# SAFETY RECALL

Date	Number	Page
10/20	RVXX2005	1 (13)

## **Sleeper Bunk Window, Repair VN**

Figure 1. Plastic Hinge

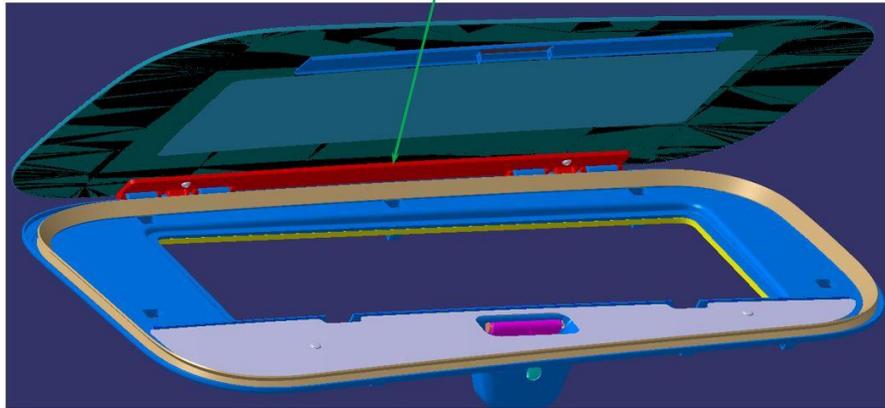
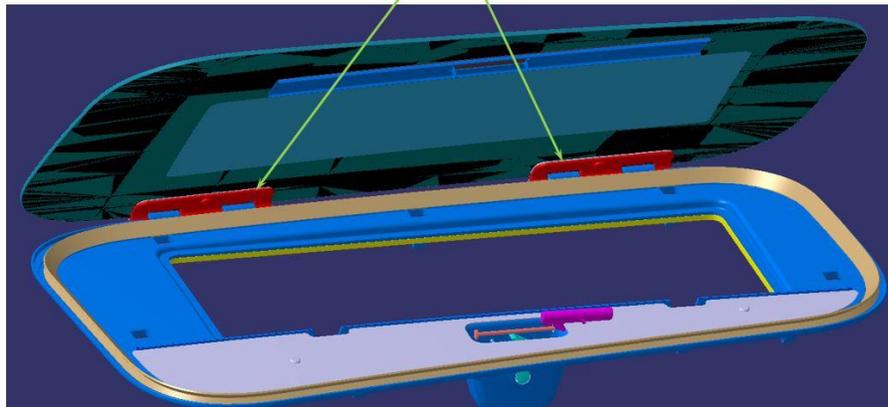
VNL740 models have the two lower side windows to be repaired. VNL760 models have both the lower side windows and upper side windows to be repaired.

The window hinge and mounting hardware are insufficient to hold the window in place if the truck is driven with the sleeper bunk windows open. If the window detaches from the vehicle, it may strike another vehicle or pedestrian increasing the risk of personal injury or a vehicle crash.

“Old” Hinge  
Single Plastic Piece Across  
Both Hinge Sites

“New” Hinge  
Two Separate Aluminum Pieces  
One At Each Hinge Site

7. If the truck is found with metal hinges, reassemble the window and claim inspection labor code.
8. If the truck is found with plastic hinges, proceed with repair and claim primary labor code.

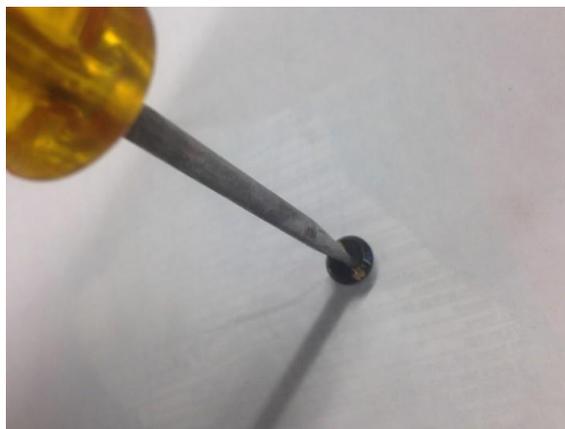
1. Remove the upper hinge screws using the special tool in the kit. Some nut inserts will stay in place when the screw is removed. Nut inserts that try to spin in place can be helped with the rubber pad included in the special tool kit. If a nut insert continues to spin, cut a slot in the head of the nut insert and use a flat head screwdriver to hold in place.

- Using thin tie strap cutters, cut the glass side of the hinge from the window cab side. With the glass removed, cut the center section of the hinge from the window frame as shown. This will provide the space that is needed to mount the new hinge.

- Use a putty knife to de-bond the plastic hinge strip from the glass.  
**Note:** Be careful when removing the plastic hinge strip not to scratch the surface.

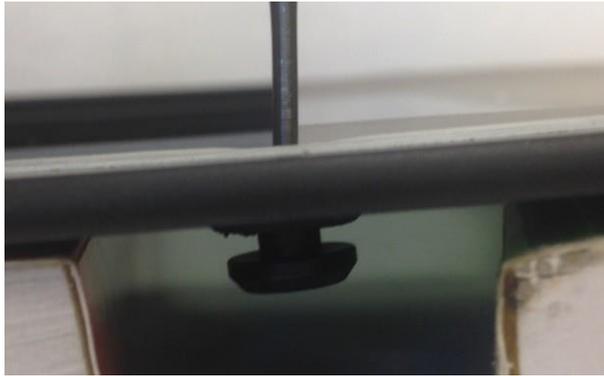
4. Remove the two nut inserts from the glass.

5. Remove the two insulators from the outside glass.

6. Remove the old glue from the mounting holes.

**Note:** Be careful removing the old glue from the mounting holes.

7. Install the “E” clip from the kit on one side of each new hinge pin. There should be 4 pins in total.

8. Place the two new metal hinges from the kit on the window frame and install the pins.

9. Install “E” clips onto the hinge pins.

10. Install two plastic nut inserts into the glass mounting holes.

11. Install the glass. Install the nuts and torque (2 Nm +/- 0.1 Nm).

12. Install the two nut caps. Ensure the nut covers are fully seated.

13. Install the latch pin.

14. Install an "E" clip on the latch pin.
